Appl. No. 09/804,022  
Amdt. Dated October 4, 2004  
Reply to Office Action of July 20, 2004

### REMARKS

FIG. 1 (Prior Art)

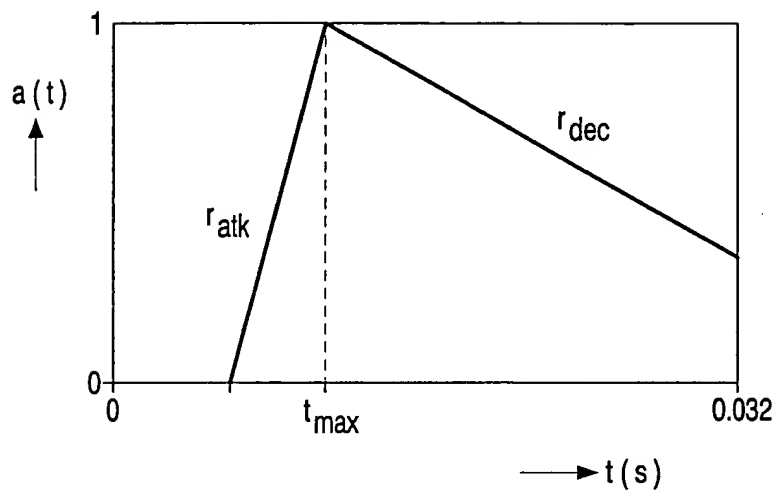
The Examiner also objected to the drawings with regard to Figure 1, indicating that there should be a designation included by a legend such as - - Prior Art - -. Applicants have  
20 corrected the drawing sheet for Figure 1 by including the label "Replacement Sheet" in the page header, and by including in parenthesis to right of "FIG. 1" the legend - - (Prior Art) --.
